Access Compliance Report

Public Rights-of-Way

(Curb Ramps)

Intersection ID: 30218	Main Street: FINBOROUGH_CT	Cross Street: MONTBROOK_DR	Location: S
ADA ID: 9CE49F190D87	Ramp Type: PerpDiag	Initial Pass/Fail: Fail	Overall Compliance: No
		Severity Score: 10

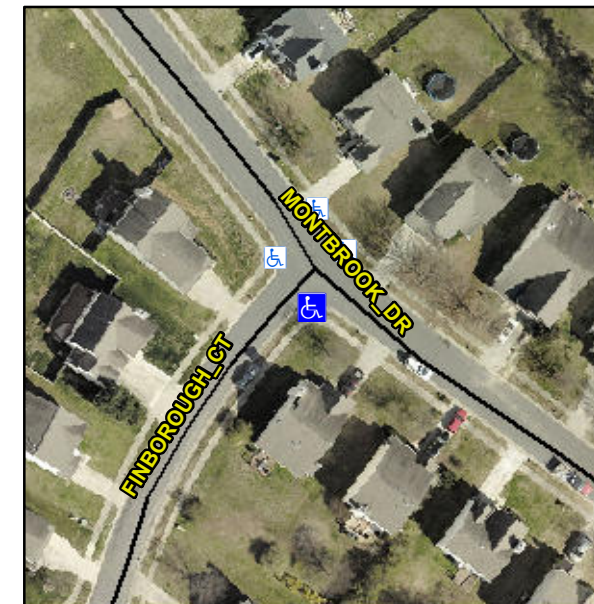
Not Found, R304.5.1, R304.5.3

Compliance	Description	Data	Compliance	Description	Data
N/A	Ramp Length (in)	49.0	Yes	Ramp Slope (%)	6.0
No	Ramp Width (in)	36.0	No	Ramp XSlope (%)	2.3
N/A	Flare Type LT	N/A	N/A	Flare Type RT	N/A
N/A	Flare Slope LT (%)	N/A	N/A	Flare Slope RT (%)	N/A
N/A	Flare Traversable LT?	N/A	N/A	Flare Traversable RT?	N/A
N/A	Landing Length (in)	N/A	N/A	DWS Provided?	N/A
N/A	Landing Width (in)	N/A	N/A	DWS Contrast?	N/A
N/A	Landing Slope (%)	N/A	N/A	DWS Length (in)	N/A
N/A	Landing X Slope (%)	N/A	N/A	DWS Full Width?	N/A
N/A	Landing Curb? (Y/N)	N/A	N/A	DWS Offset (in)	N/A
N/A	Shared Landing?	N/A			
N/A	Gutter Ponding?	N/A	N/A	Gutter Slope (%)	N/A
N/A	Gutter Lip Ht (in)	N/A	N/A	Gutter X Slope (%)	N/A
N/A	Painted X Walk1?	No	N/A	Painted X Walk2?	No
	X Walk 1 Direction	To NE		X Walk 2 Direction	To W
N/A	X Walk 1 Width (in)	N/A	N/A	X Walk 2 Width (in)	N/A
	X Walk 1 Slope (%)	4.0		X Walk 2 Slope (%)	2.9
	X Walk 1 X Slope (%)	3.0		X Walk 2 X Slope (%)	4.5

Remove & Replace Curb Ramp With Two New Directional Ramps or Equivalent.
